CONSTRUCTION STORMWATER GENERAL PERMIT INSPECTION REPORT

State of Washington Department of Ecology

Ecology Inspector(s): Carol Serdar	On-Site Representative Name: Thom Fischer Title:	Inspection Date and Entry/Exit Time: 11 Aug 2020, 14:45/18:44	Inspection Type: ERTS Response (#699710)
Contaminated CSWGP Inspector Phone: 360.742.9751 Email: carolserdar@ecy.wa.gov		Receiving waters: Puyallup River	Permit webpage: https://fortress.wa.gov/ecy/puris/FacilitySummary.aspx?FacilityId=70091

Photo 3

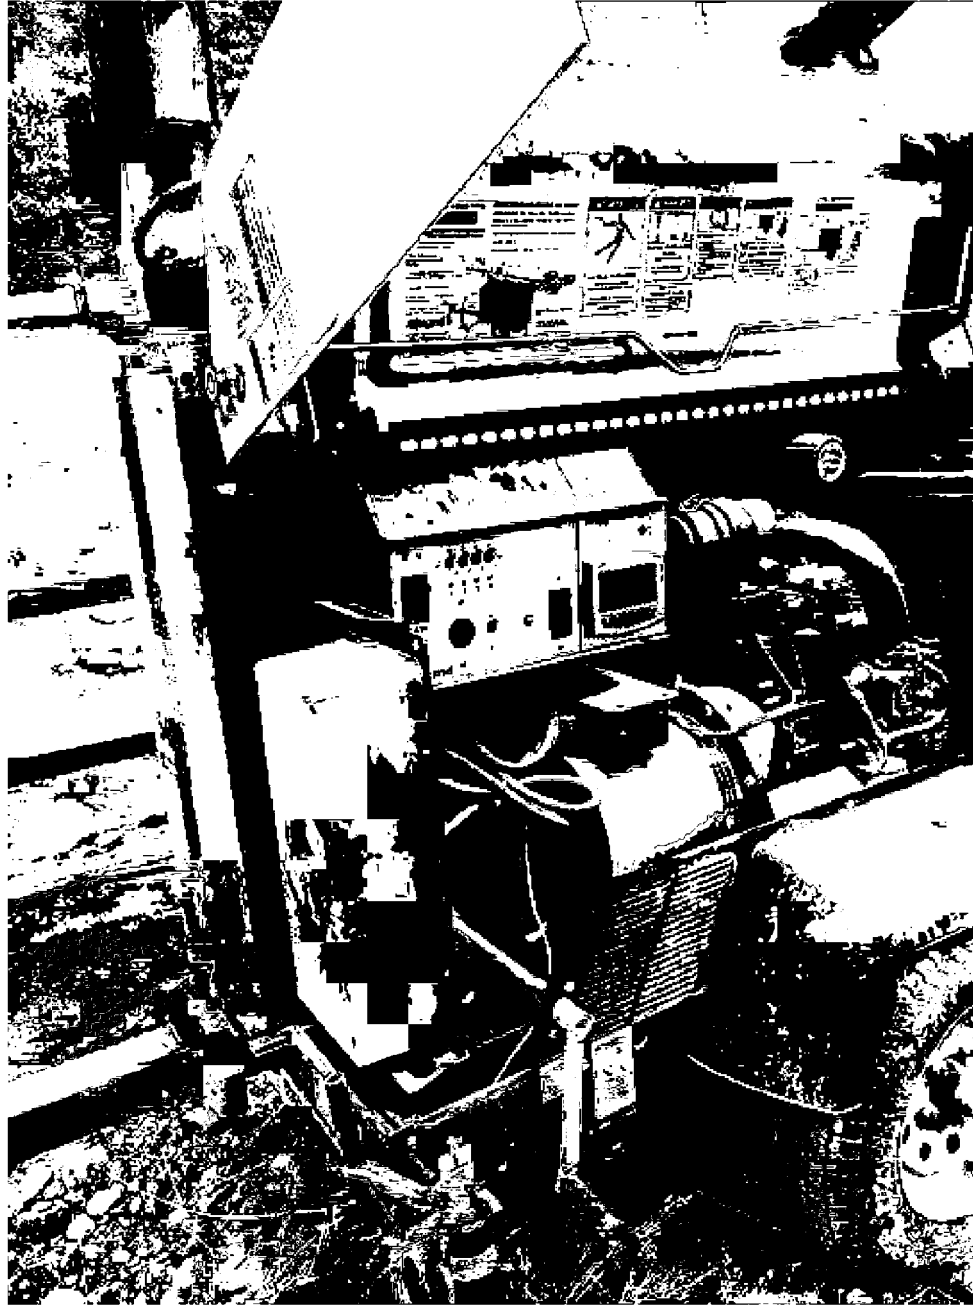
Photo Description: Light pole generator with secondary containment.

Photo 13

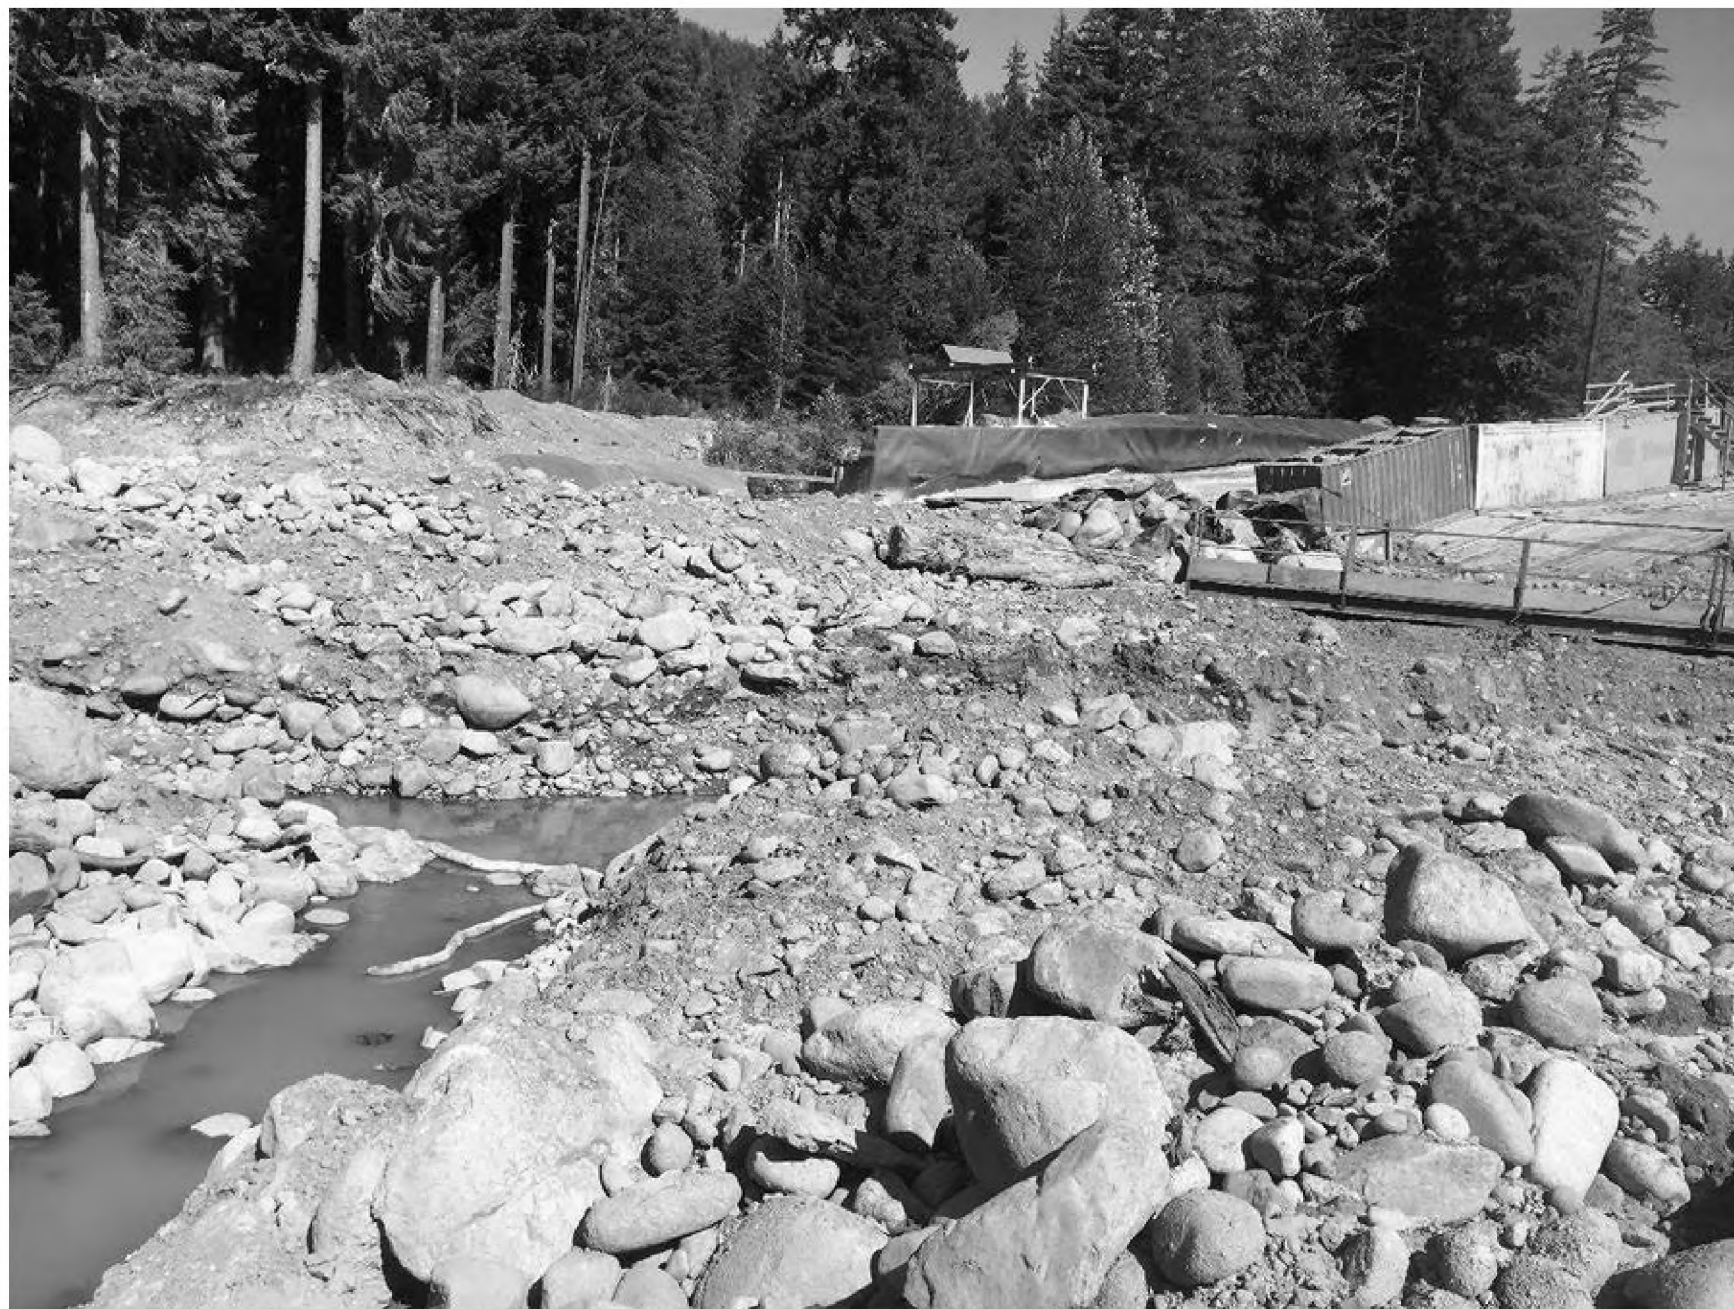
Photo Description: Oil booms are not functional when not secured as intended.
